Groundwater Transfer Review Summary Form

Transfer/PA # T- 14377 RA re-review

Application: T-14377 re-review

Applicant Name: Shortland Golf Club

Annotated Agent Cross Section- Annotations in red were made by the reviewing hydrogeologist, not the applicant's agent.

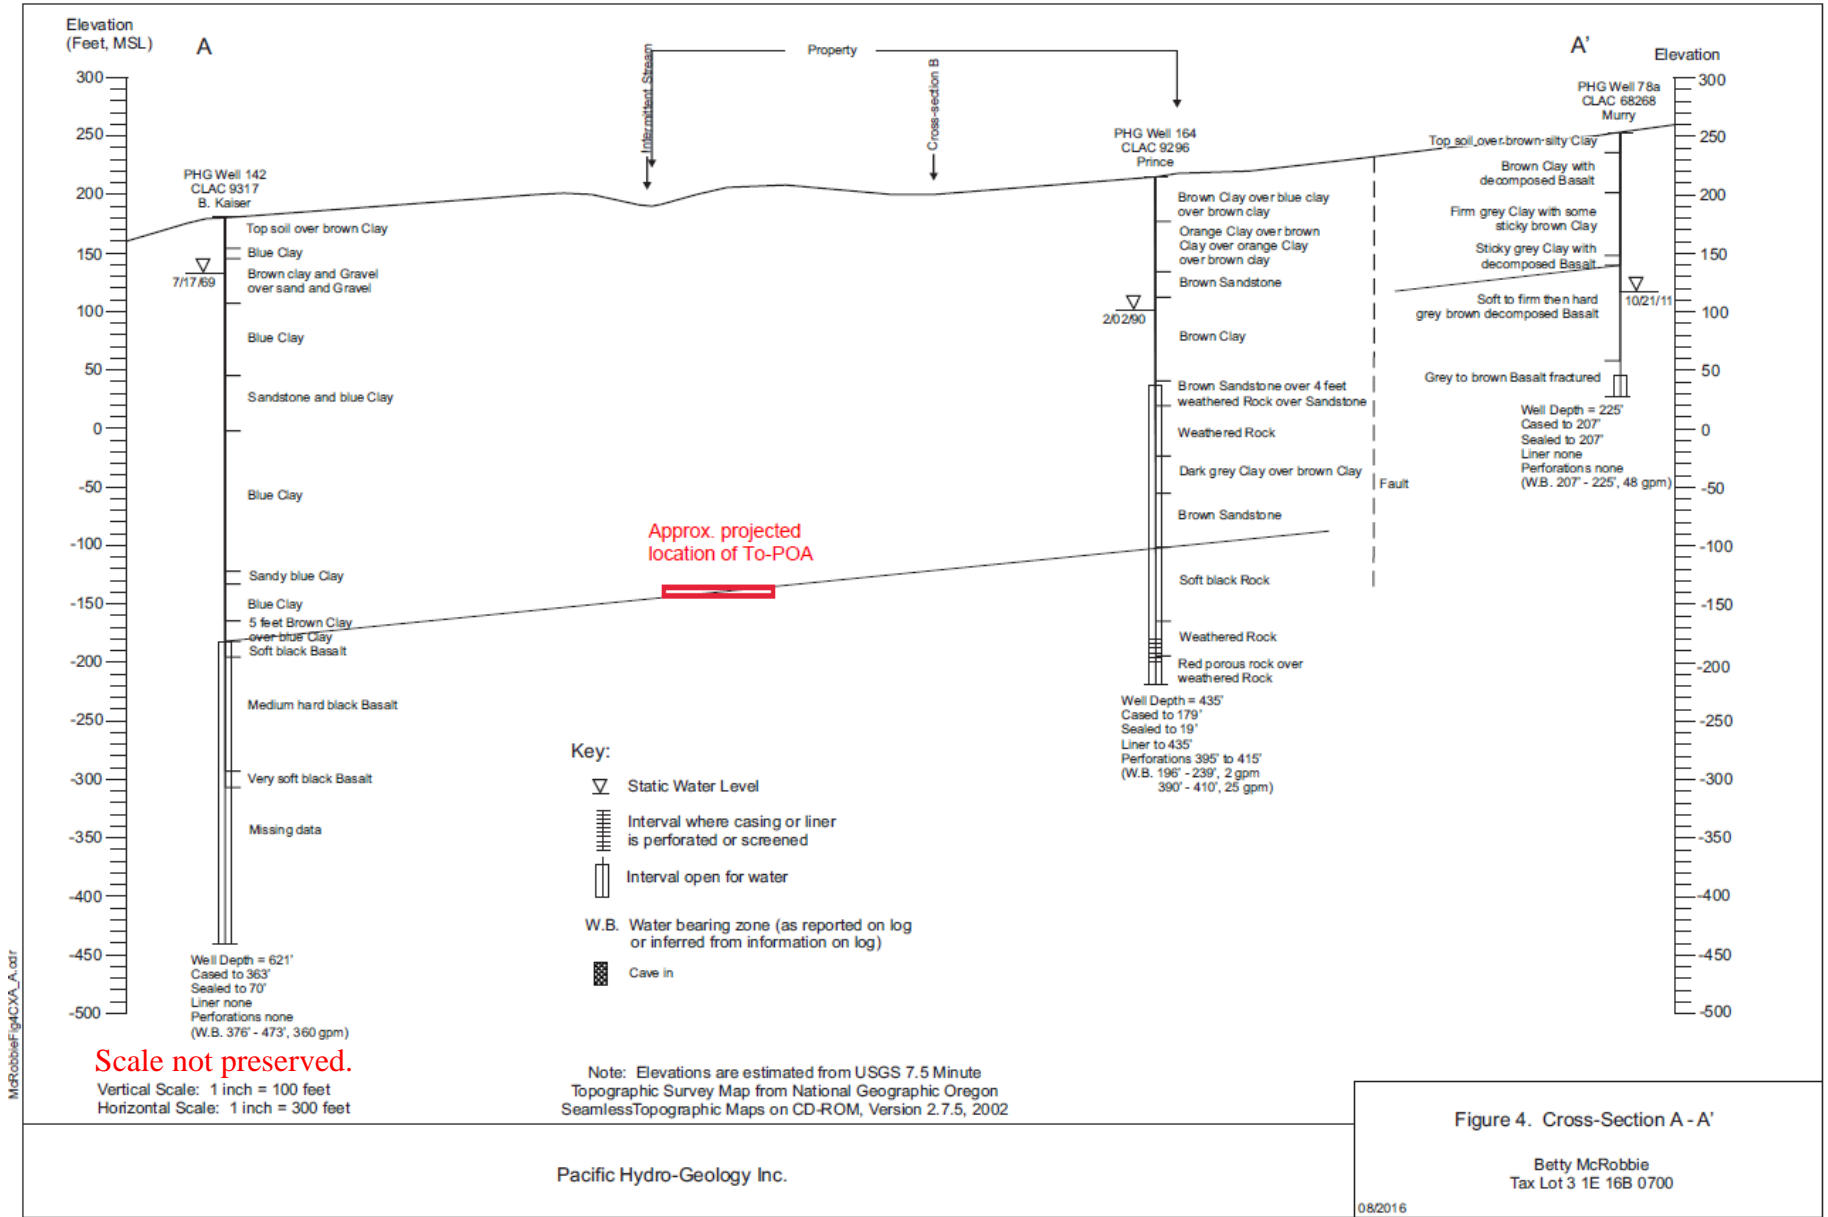
The To-POA is proposed to be completed to a total depth between 290 and 1000 ft bls, with casing and seal extending “0 to 5 feet into basalt.” **NOTE: Current well construction regulations for sealing into consolidated formations (OAR 690-210-0150) require casing and seal extend to at least five feet into solid, unfractured, consolidated rock overlying the water-bearing rock formation.** The applicant’s agent has provided analysis indicating that, at the location of the proposed To-POA, the solid, unfractured Columbia River Basalt likely exists at greater than ~370-380 ft bls (~ -140 to -150 ft msl) based on the well reports for CLAC 9317 (authorized POA) and CLAC 9296 (neighboring well) (see attached Annotated Agent Cross Section). This largely agrees with the well report for CLAC 18564, which appears to be the closest well to the proposed To-POA and indicates weathered basalt from 357 to 363 ft bls (~ -113 to -119 ft msl) and more competent basalt from 363-370 ft bls (~ -119 to -126 ft msl). Based on the well report for CLAC 18564 and the land surface elevation at the proposed To-POA, the proposed To-POA would need to be cased and sealed to at least ~350 ft bls to meet well construction standards and only produce from the basalt aquifer. If constructed and sealed into the solid, unfractured basalt, the proposed To-POA will develop the same source as the authorized POA.

Well Interference Analysis

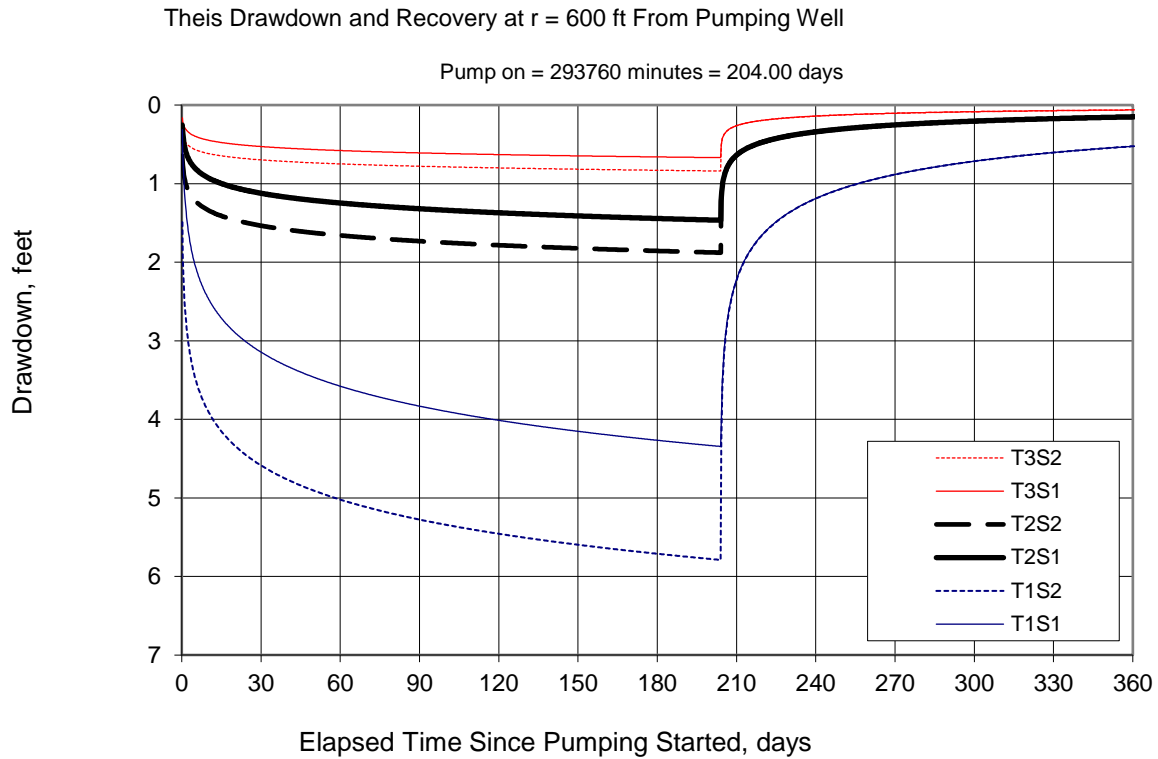
- b) If yes, would this proposed change, at its maximum allowed rate of use, likely result in another groundwater right not receiving the water to which it is legally entitled?
 Yes No If yes, explain: The potential interference between the proposed To-POA and CLAC 285 was evaluated at the proportional maximum rate of 0.073 cfs using the Theis (1935) solution for drawdown in a confined aquifer (see attached Well Interference Analysis. Based on the results of the analysis, the proposed change is unlikely to result in injury to CLAC 18564 or similarly located basalt wells.

Radial distance, r = 600 ft [approximate distance from To-POA to CLAC 18564]

Pumping time, $t_{pump} = 204$ days [time to exhaust duty at maximum proportional rate]

Pumping rate, Q = 0.073 cfs [maximum proportional rate under Certificate 50575]

Transmissivity, T1 = 800 ft²/d | T2 = 2,800 ft²/d | T3 = 6,800 ft²/d [Pumping Test Reports]

Storativity, S1 = 0.001 | S2 = 0.0001 [Conlon et al., 2005]
